## SERVICE BULLETIN NO. MSB1078-164

ATA-Code:	52-10 Canopy – Canopy Jettison
-----------	-----------------------------------

G 115C/D/E

Fig. 1

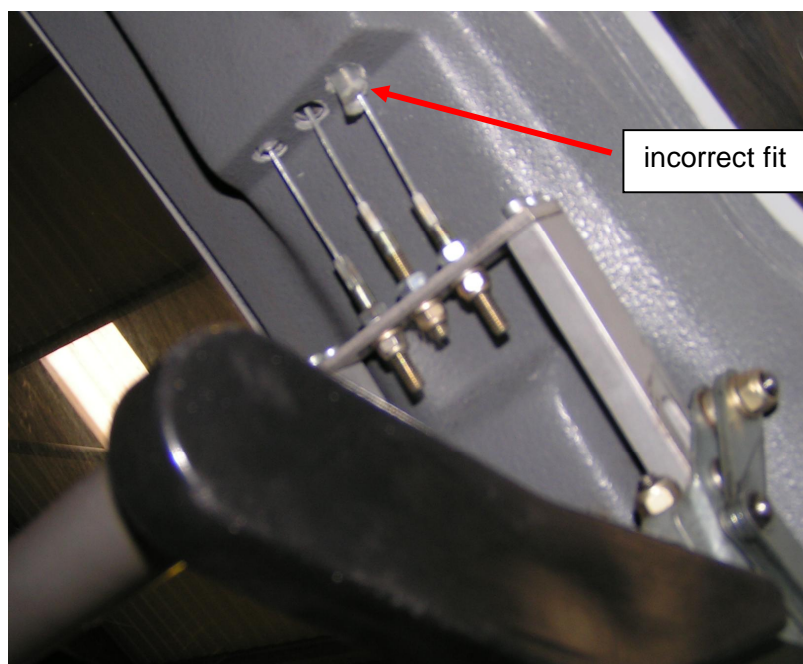
Grob received an occurrence report of a failed canopy jettison test, experienced during a regular maintenance check. The investigation revealed, that a cable shroud of the jettison system protruded the canopy structure, which probably caused the malfunction (see Fig. 1).

- ensure that all jettison pins are withdrawn before the canopy handle contacts the rear handle cover
- check that the LH and RH handle protection covers do not contact the rear handle cover
- remove the rear handle cover and inspect the area where the jettison cables enter the canopy structure (see Fig. 1) for evidence of the cable outer shroud becoming detached from the canopy structure
- check canopy handle for excessive wear in the mechanism

1.8.3. If the jettison fails a repair according to a repair instruction provided by Grob must be performed and/ or the canopy handle must be replaced I.A.W. MM chapter 52-10.

### Appendix 1: Inspection Report

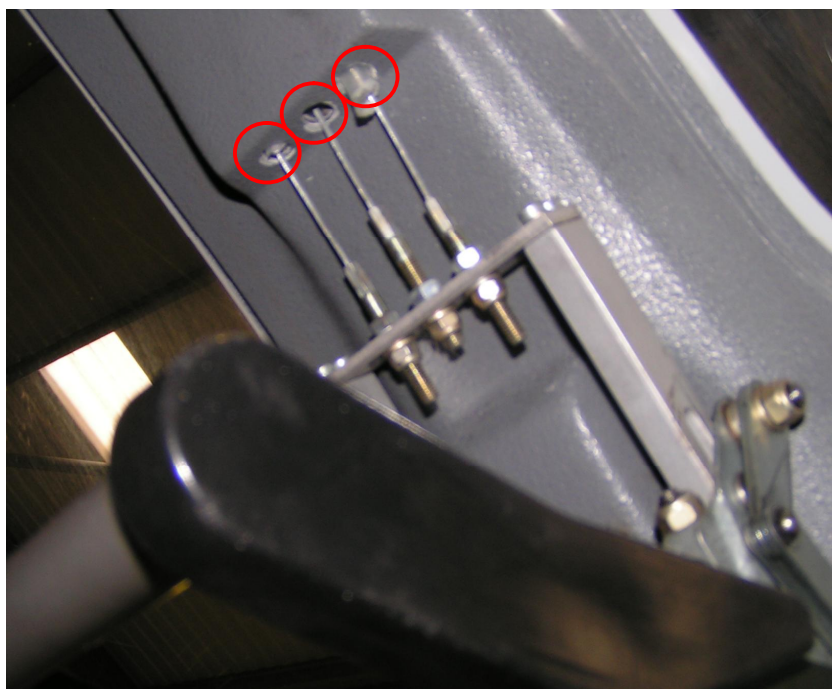
Discrepancy found:  NO  YES (please mark relevant position)

Canopy handle has excessive play and need to be replaced:
